ADDENDUM # 1

DATE: April 11, 2025

**FOR: PCDL – NEW LEXINGTON
ADDITION & RENOVATION**

LS-100

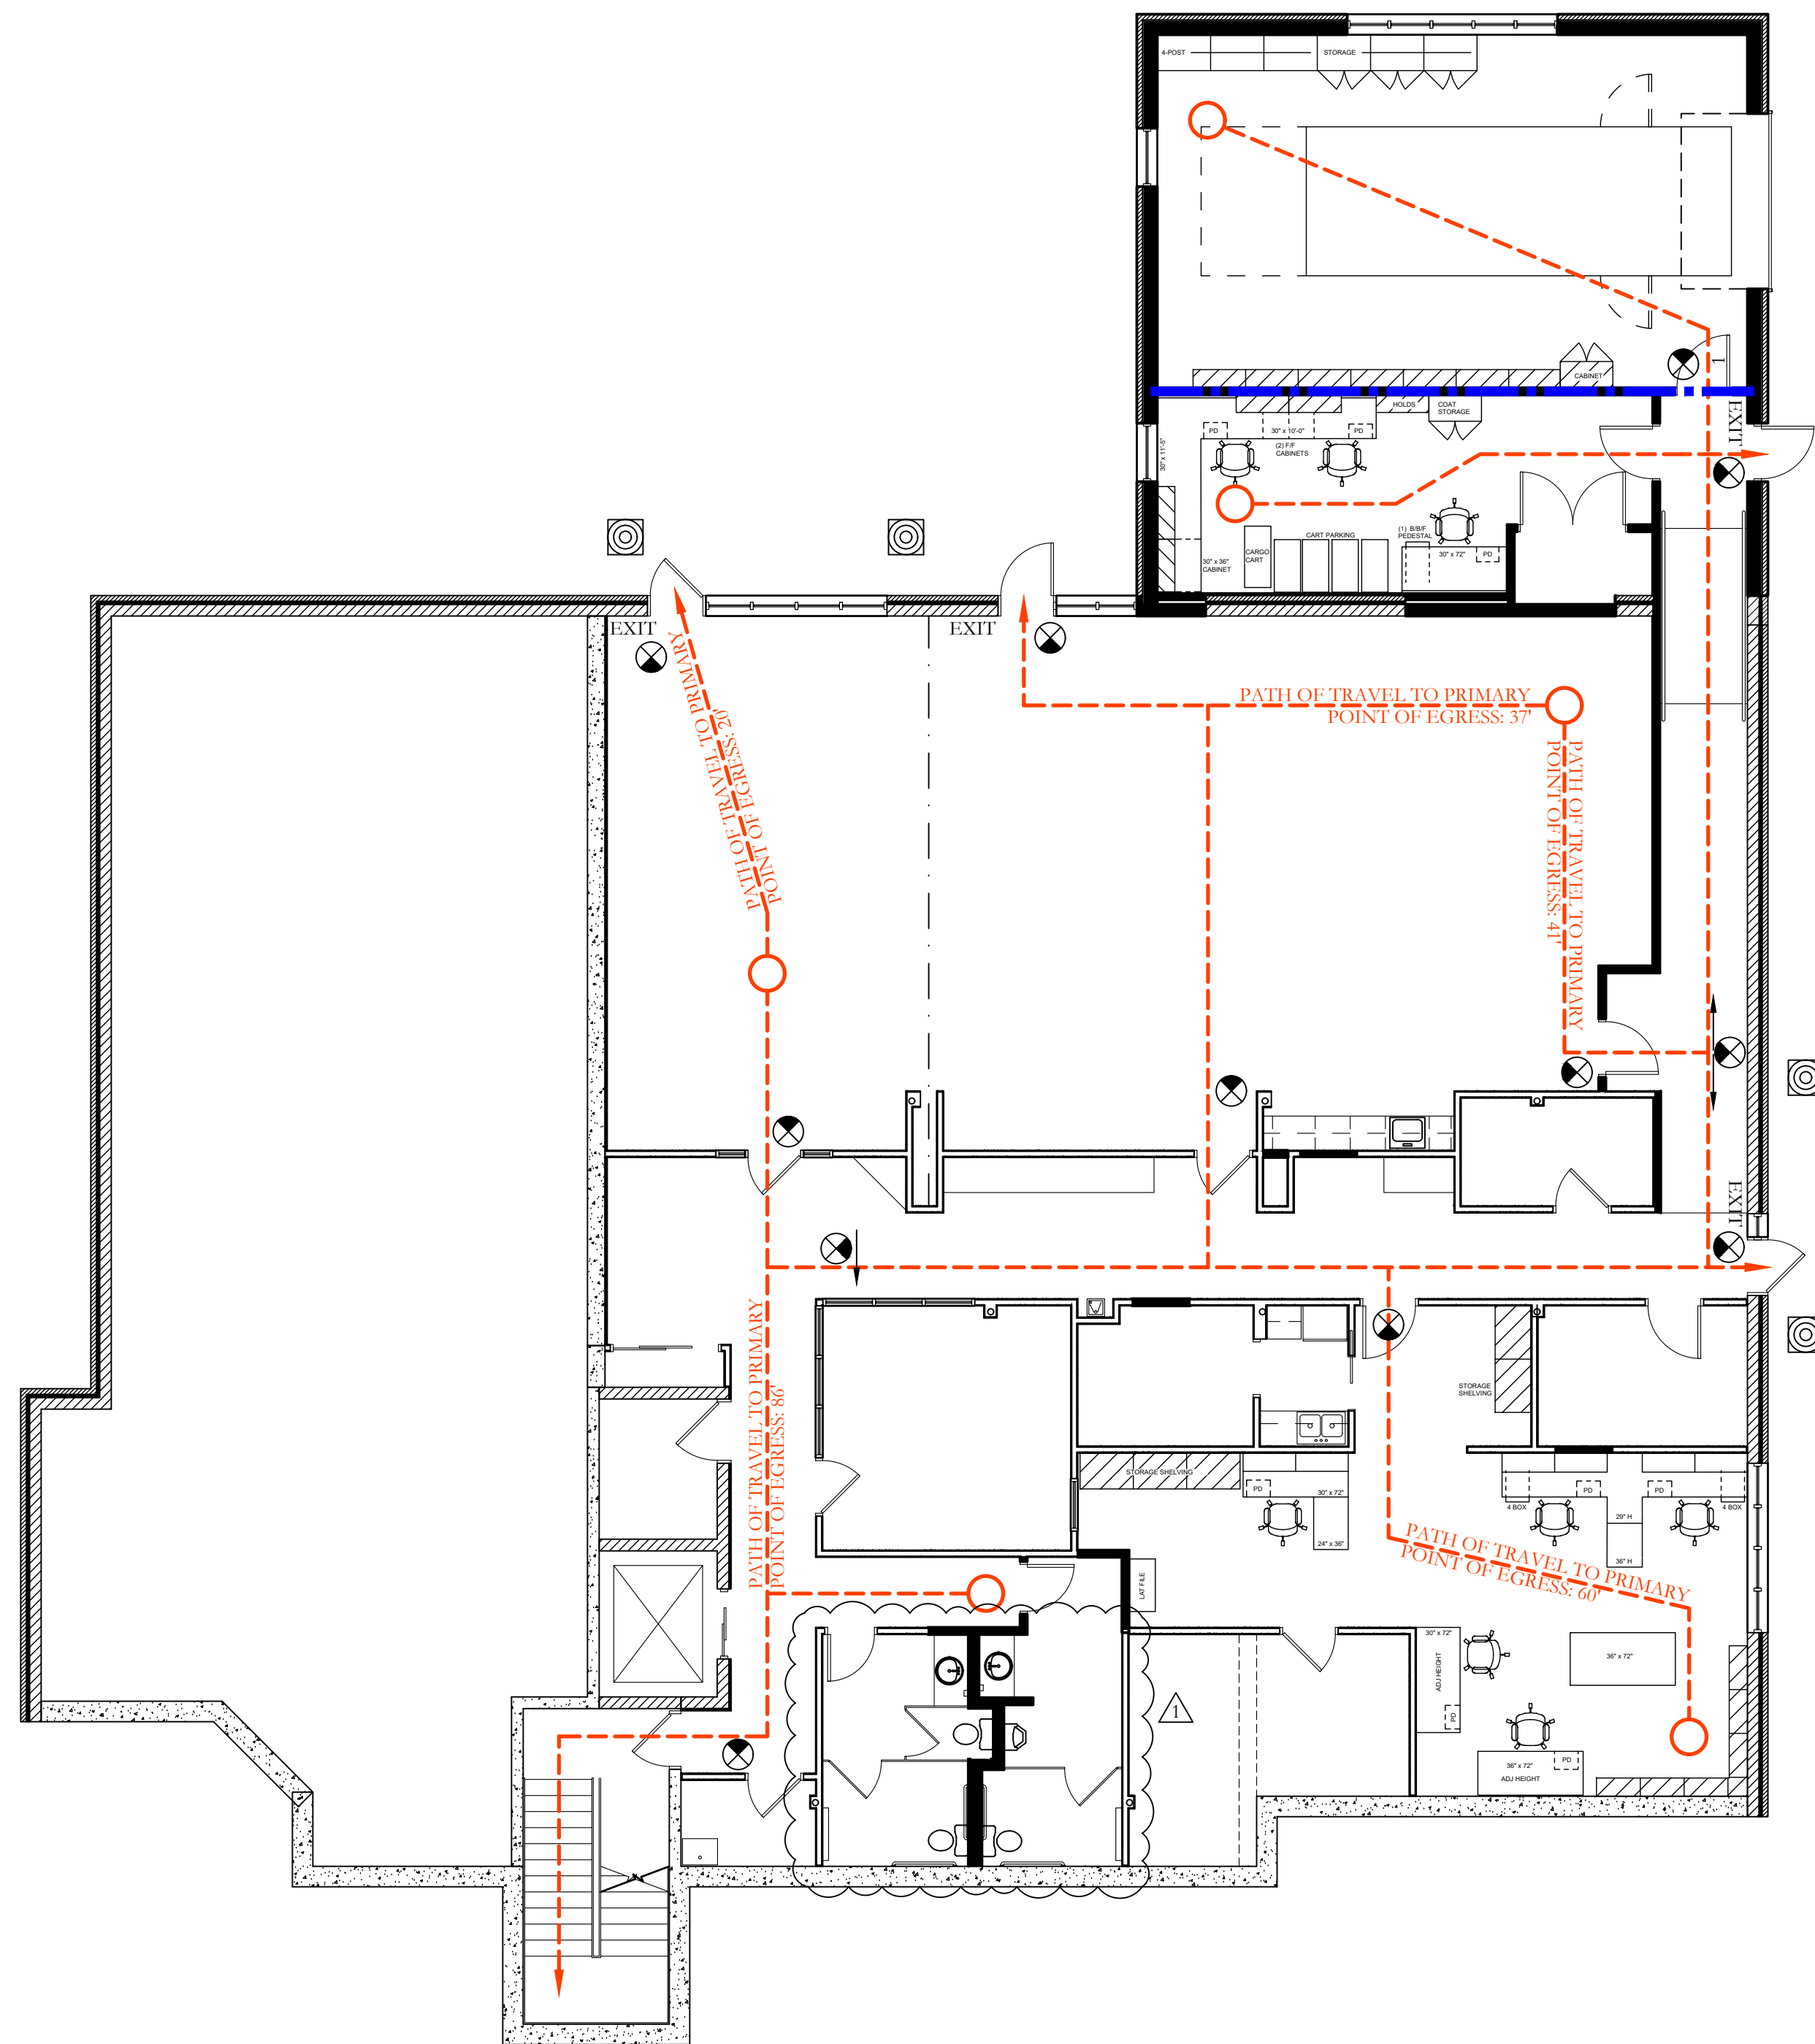
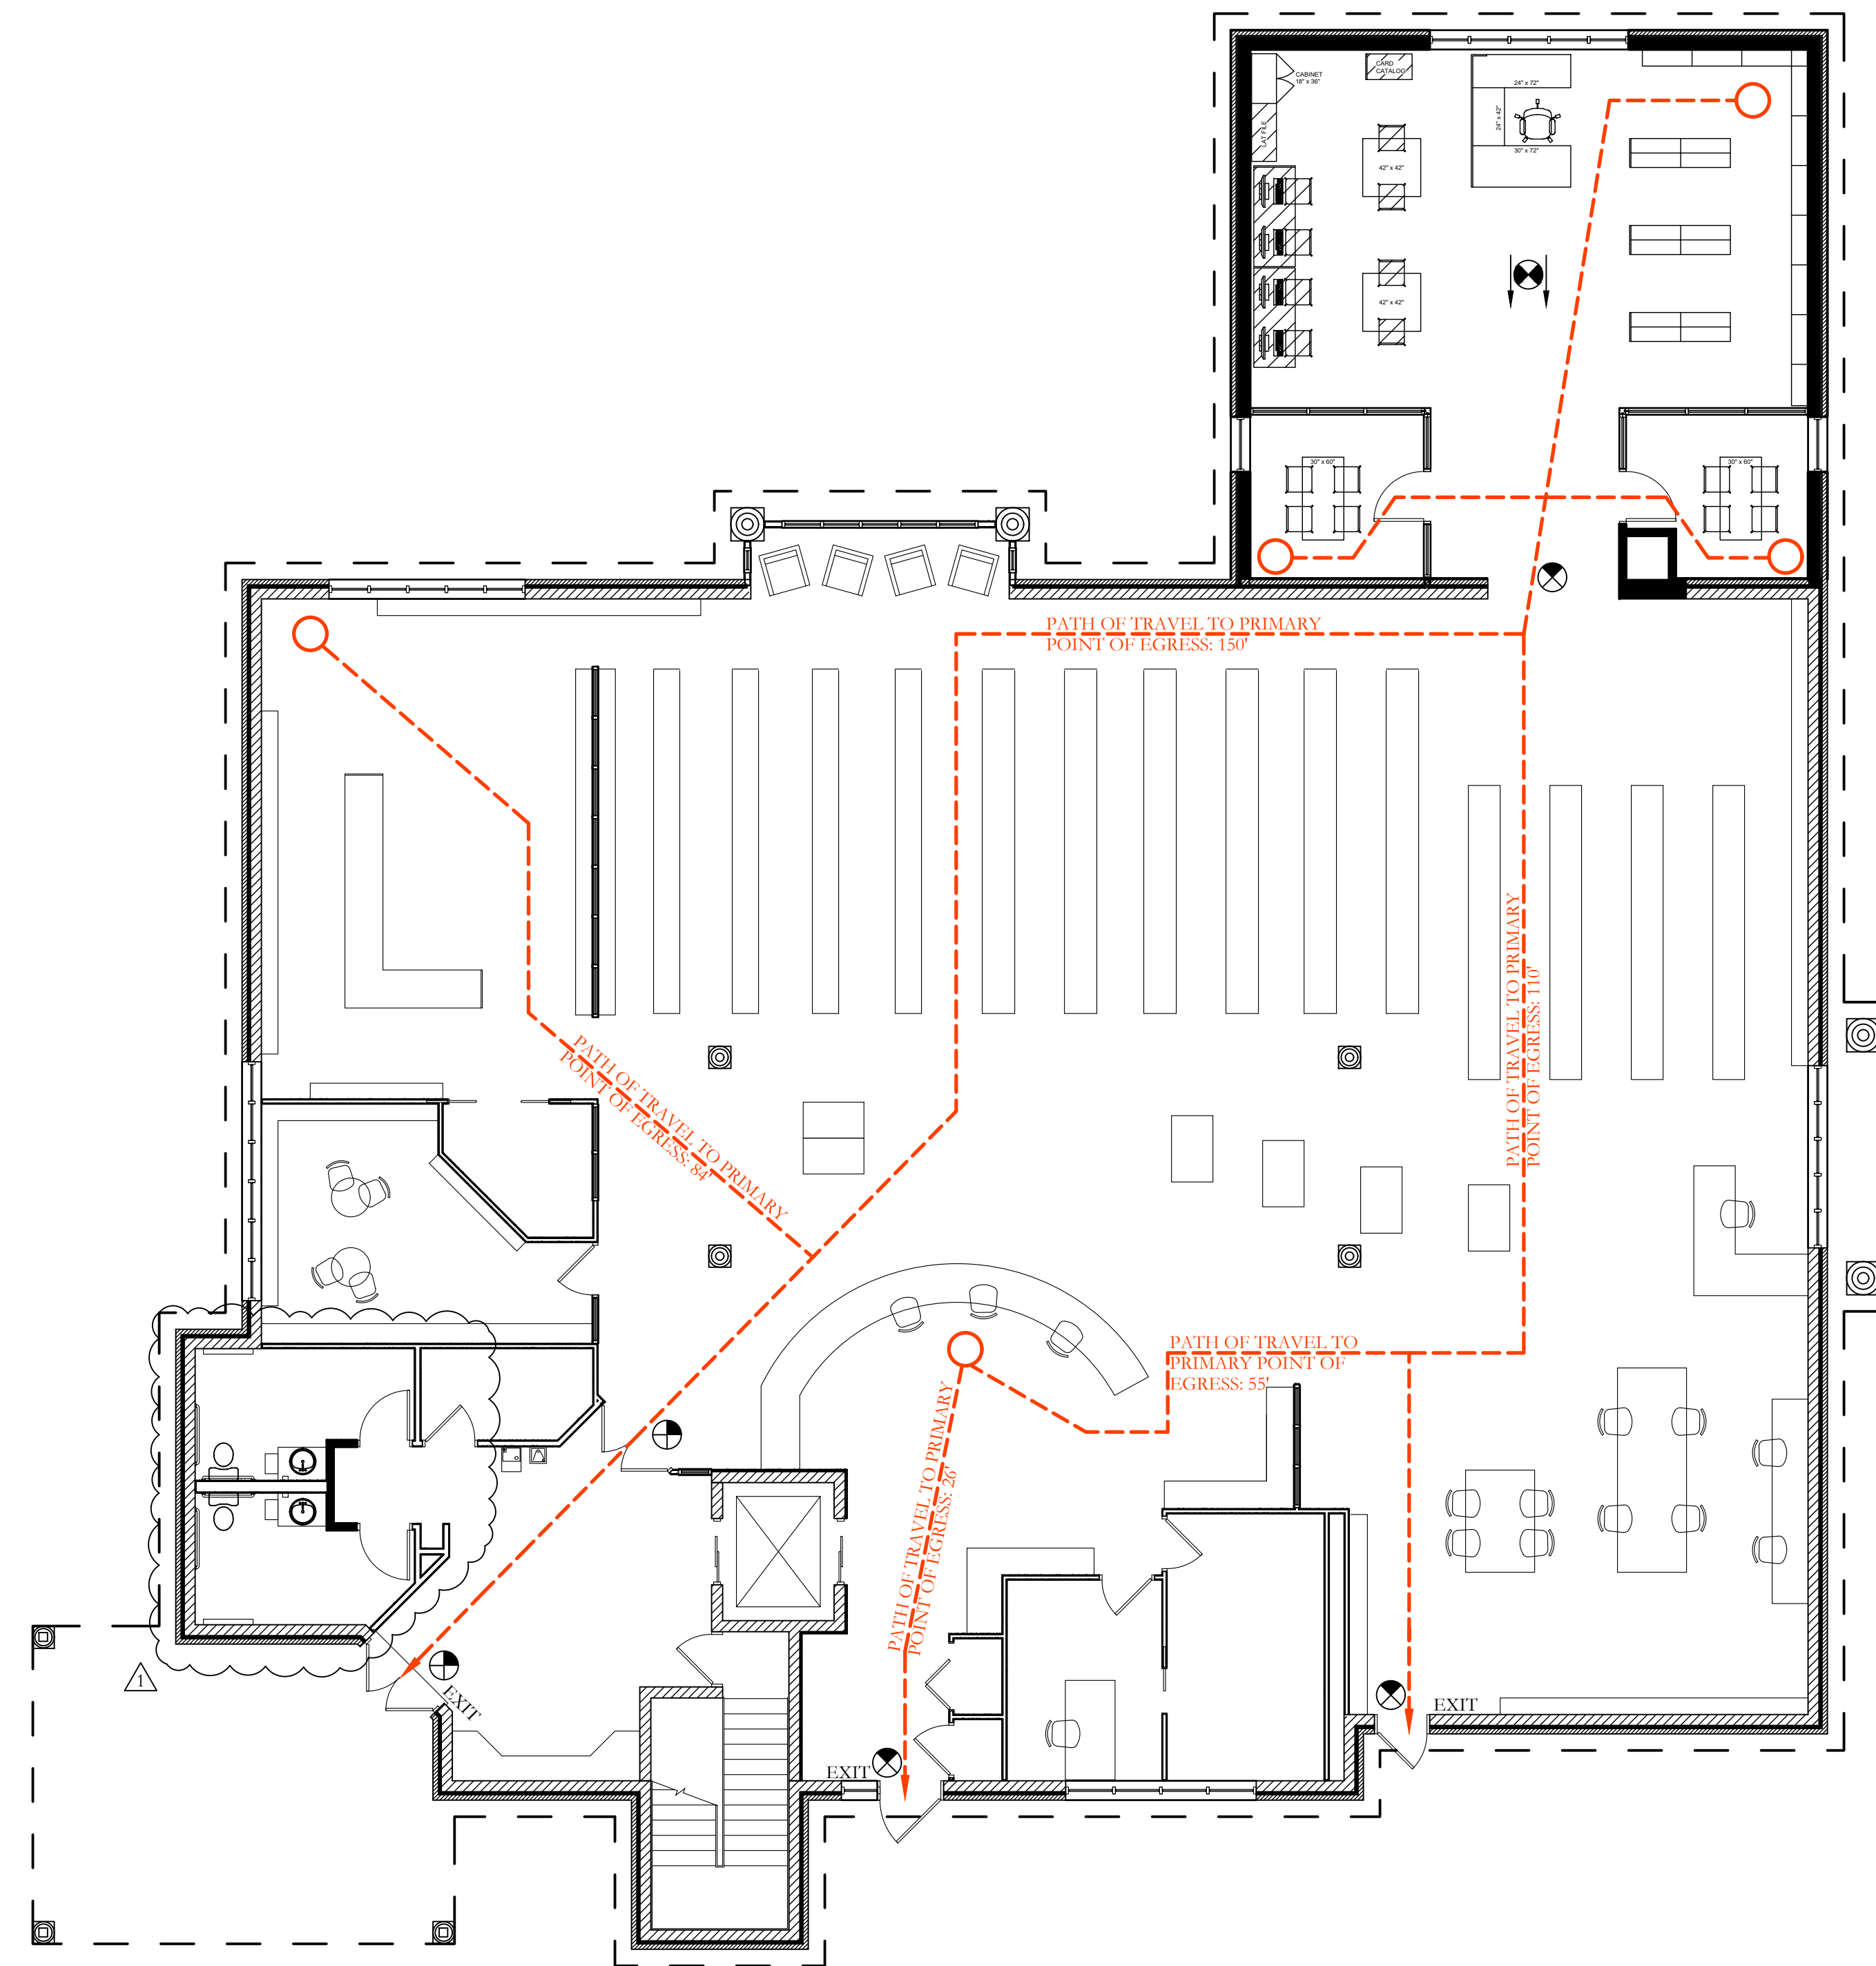
Item #2 Life Safety Floor Plan – replace LS-100 with attached

- a. Remove paper towel dispensers in restrooms (Women’s 004, Men’s 005, Women’s 103, Men’s 104) – Owner will furnish paper towel dispensers, and Contractor will install.
- b. Added missing existing door #102A (Janitor/Mech 102)

A-100

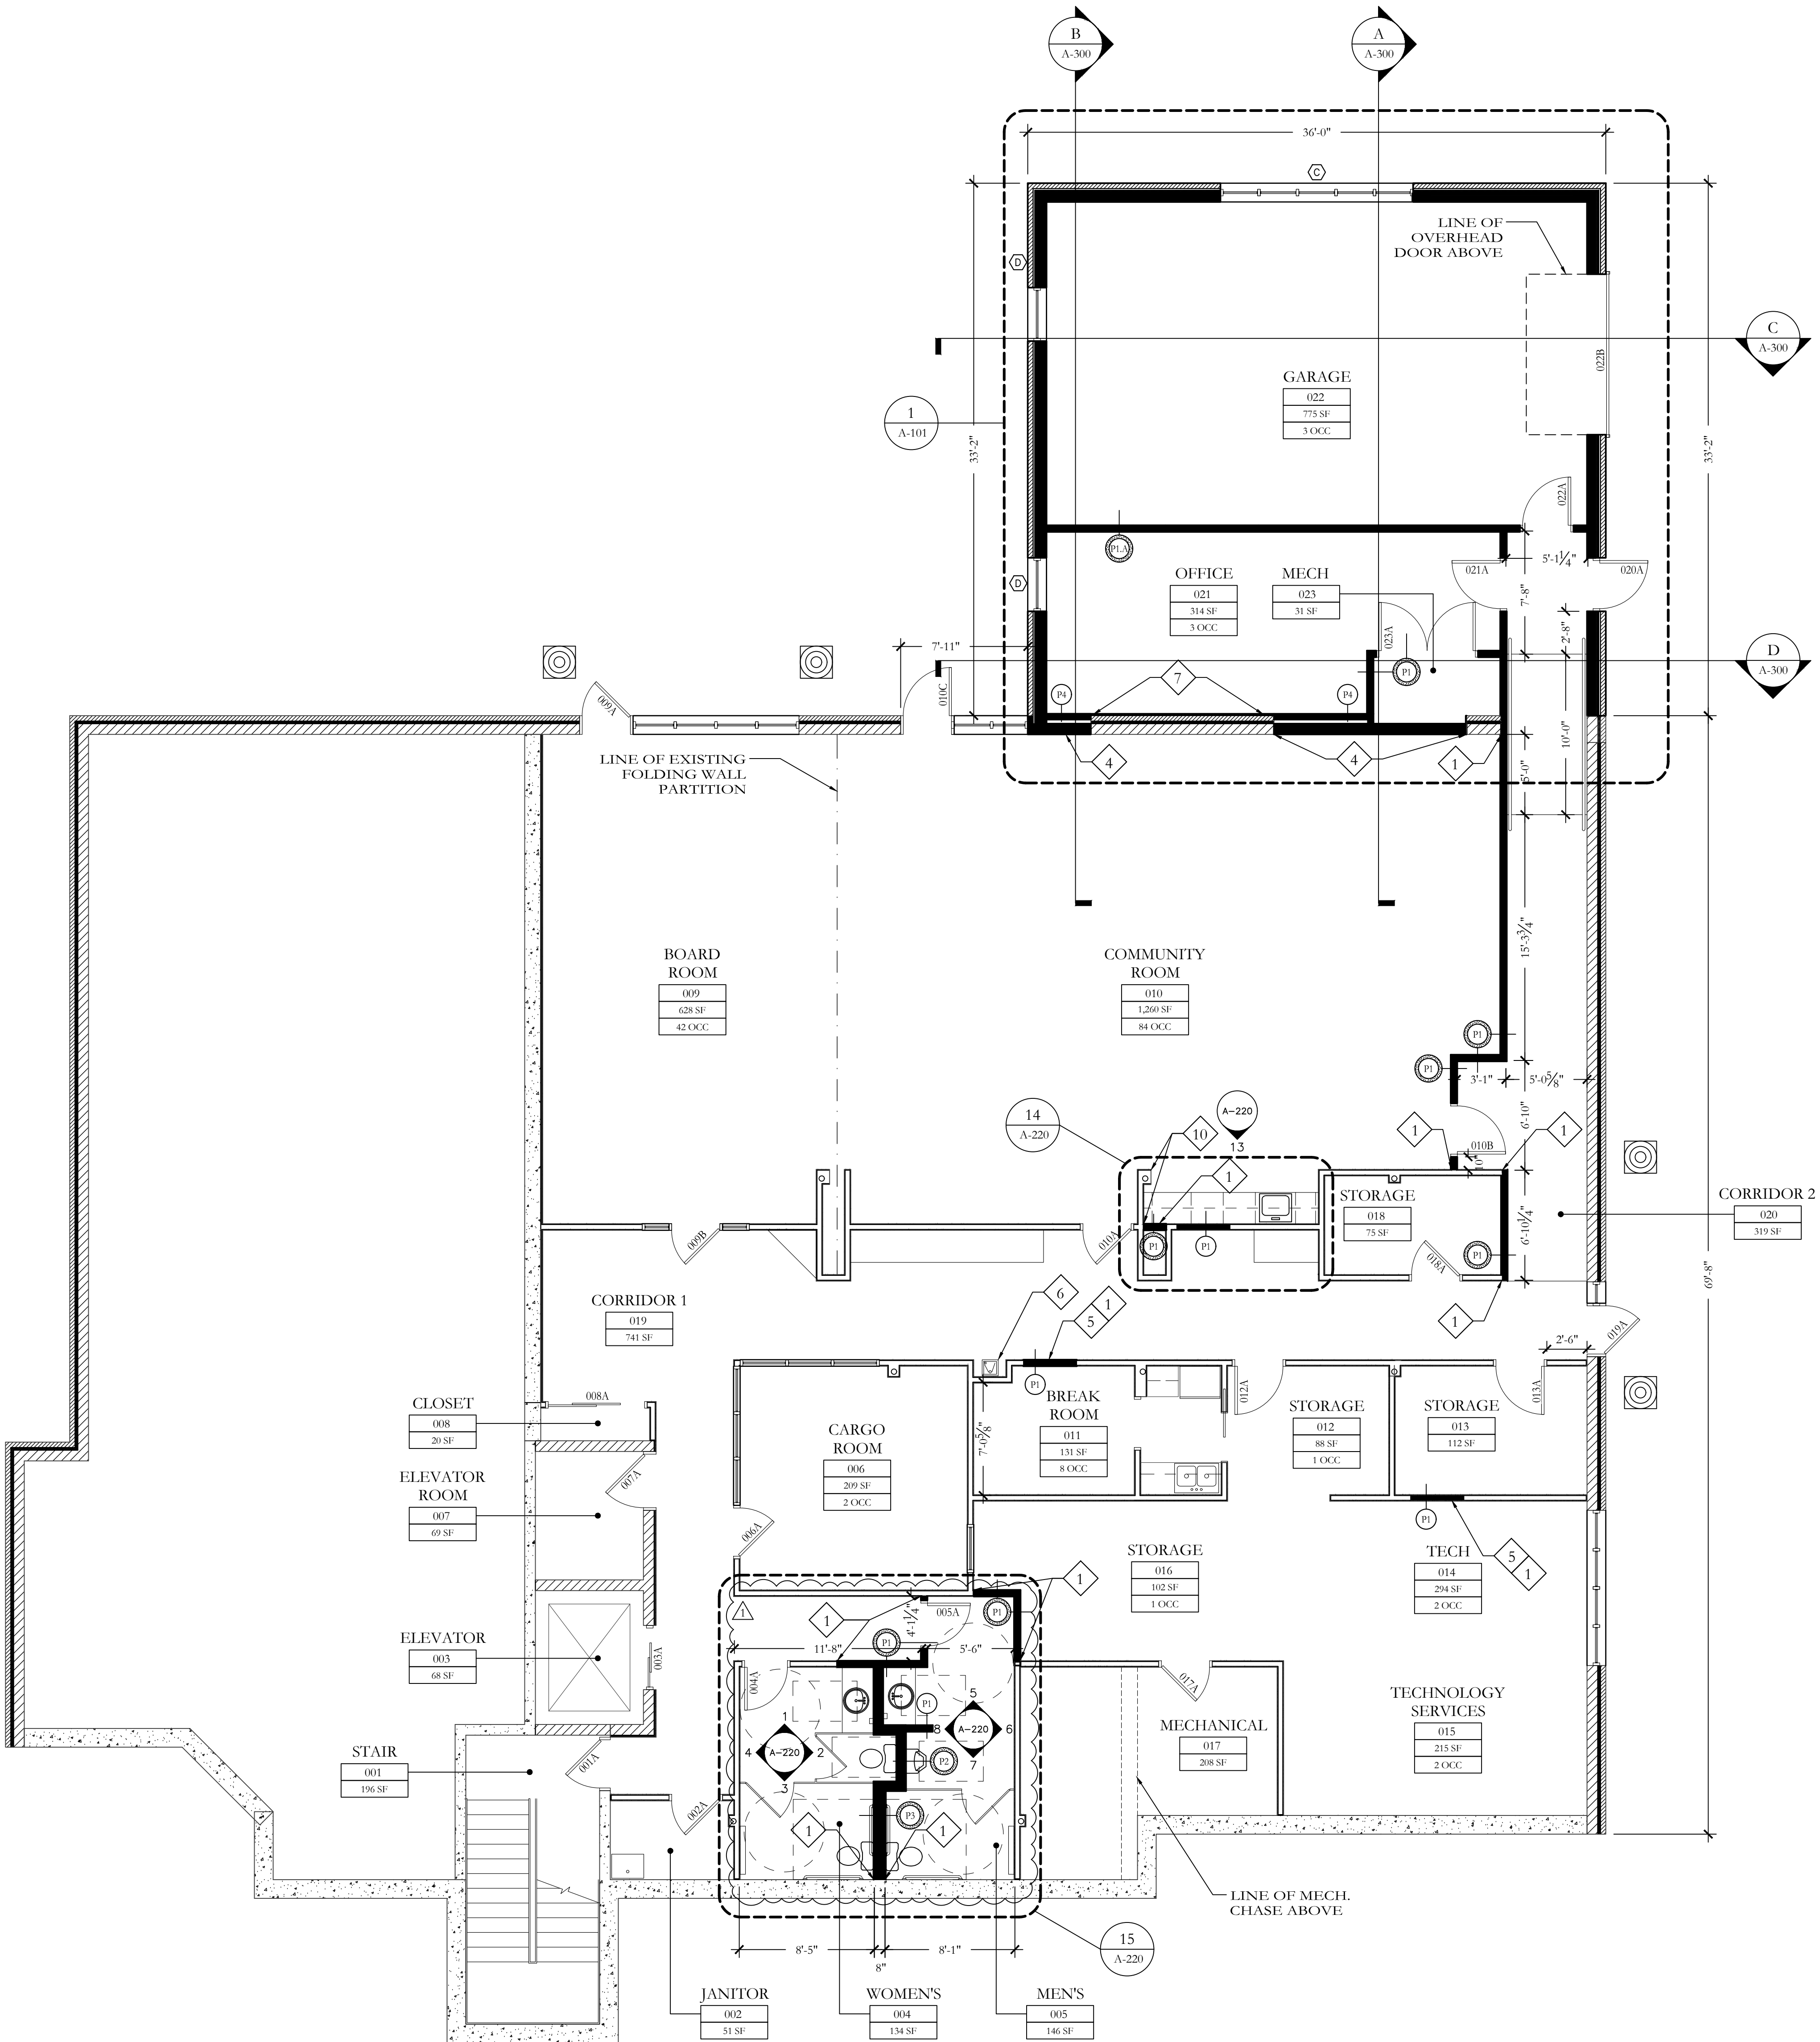
Item #3 New Construction Lower-Level Floor Plan – replace A-100 with attached

- a. Remove paper towel dispensers in restrooms (Women’s 004, Men’s 005, Women’s 103, Men’s 104) – Owner will furnish paper towel dispensers, and Contractor will install.
- b. Added missing existing door #102A (Janitor/Mech 102)
